NUCLEAR MANAGEMENT COMPANY, LLC
PALISADES NUCLEAR PLANT, DOCKET 50-255, LICENSE DPR-20
REQUEST FOR CHANGE TO PALISADES PLANT TECHNICAL SPECIFICATION
MAXIMUM ALLOWED VALUE FOR VARIABLE HIGH POWER TRIP

**TECHNICAL SPECIFICATION CHANGE REQUEST
ALLOWED VALUE FOR VARIABLE HIGH POWER TRIP**

**LICENSE AMENDMENT REQUEST PURSUANT TO 10 CFR 50.90:
TECHNICAL SPECIFICATION MAXIMUM ALLOWED VALUE FOR
VARIABLE HIGH POWER TRIP**

FIGURE 1:
Proposed VHP Trip Calculated Setpoint, and New Technical Specification Allowable Value

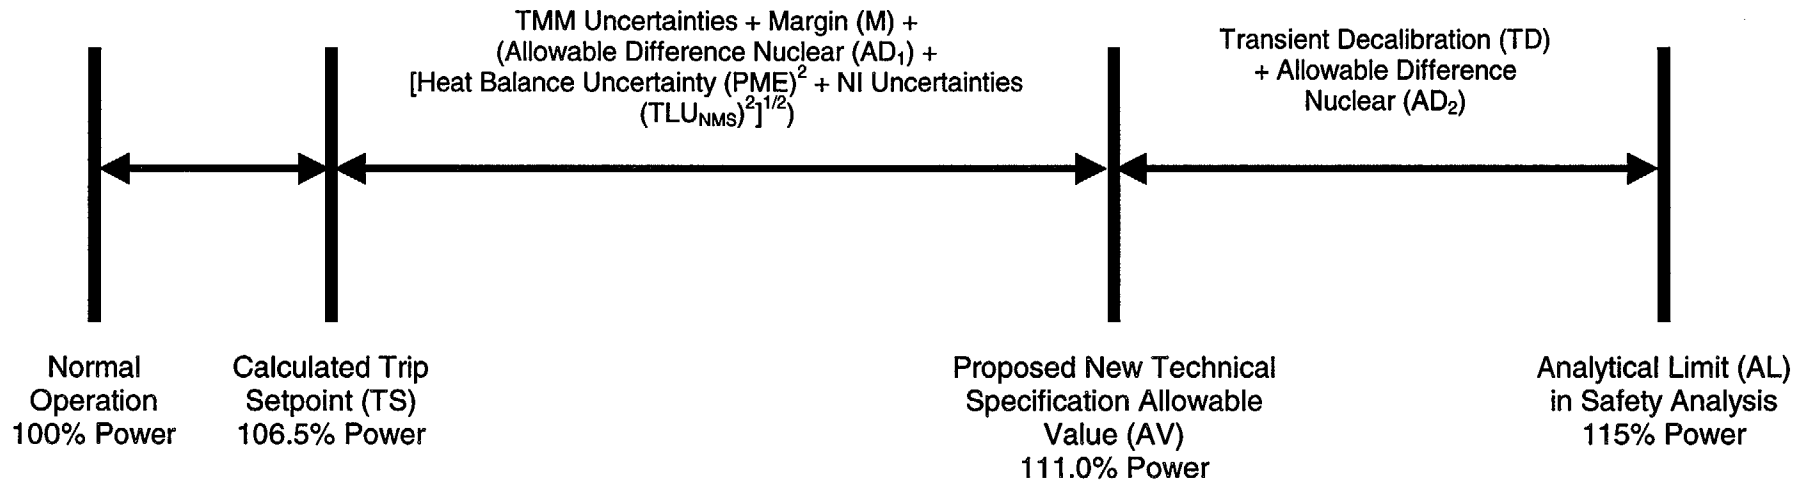
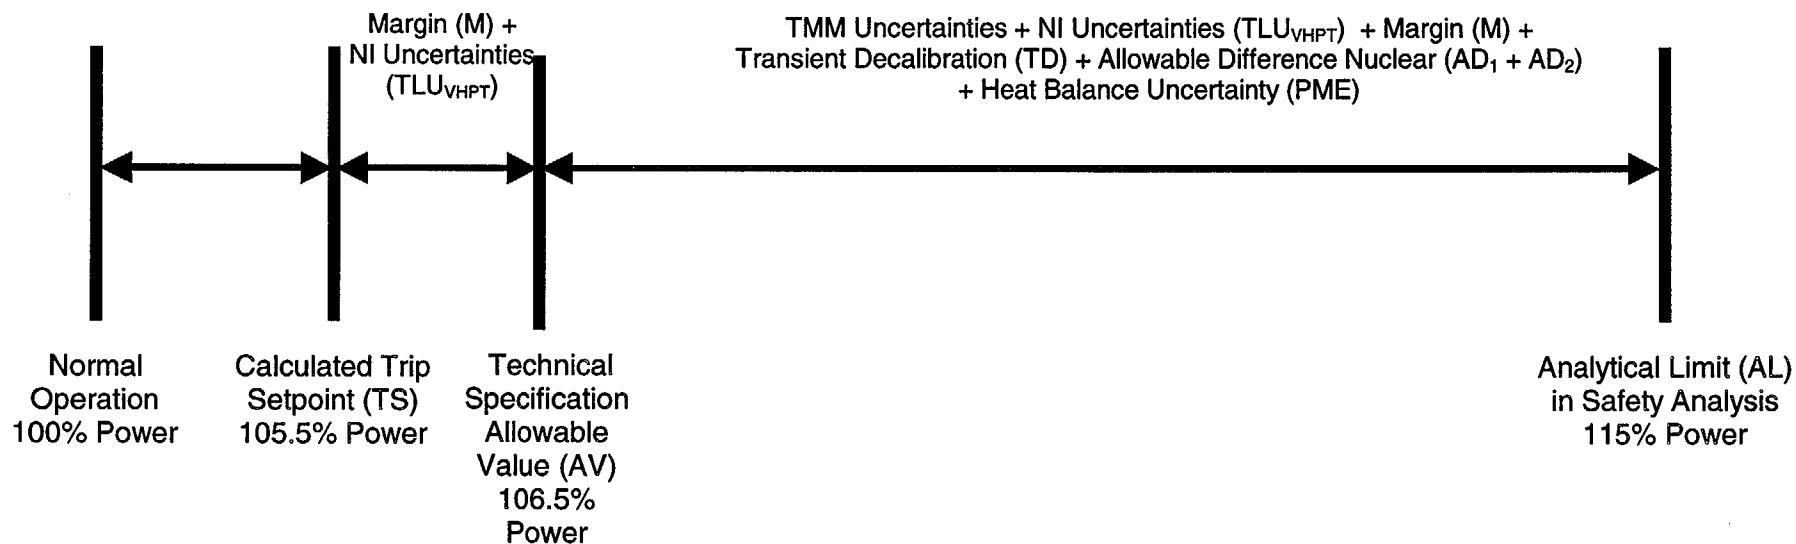
See Figure 1 for a visual representation describing how the different uncertainty terms were applied in determining the VHPT allowable value and the calculated trip setpoint. Figure 2 is included for comparison purposes. It describes the current application of uncertainty terms for the AV, TS and AL and shows how the NI Uncertainties are accounted for twice.

The proposed change to the maximum Allowable Value for the Variable High Power Trip function in the Technical Specifications would account for all uncertainties in the VHP trip setpoint calculation, instead of taking them into account in the maximum allowable value calculation, as is currently done. In addition, double accounting for nuclear instrumentation uncertainties has been removed. The uncertainties will still be taken into account in determining the calculated setpoint based on the maximum allowable value of the VHPT, in accordance with the standard ANSI/ISA-S67.04-1994 and NRC Regulatory Guide 1.105, Revision 3. This methodology continues to assure that the Analytical Limit will not be exceeded.

$$\begin{aligned}\text{New VHP Trip Allowable Value, AV} &= \text{TS} + (\text{AD}_1 + [\text{PME}^2 + \text{TLU}_{\text{NMS}}^2]^{1/2}) + \text{M} \\ &= 106.5\% + (2.0\% + [2.0\%^2 + 0.5\%^2]^{1/2}) \\ &\quad + 0.44\% \\ &= 111.0\%\end{aligned}$$
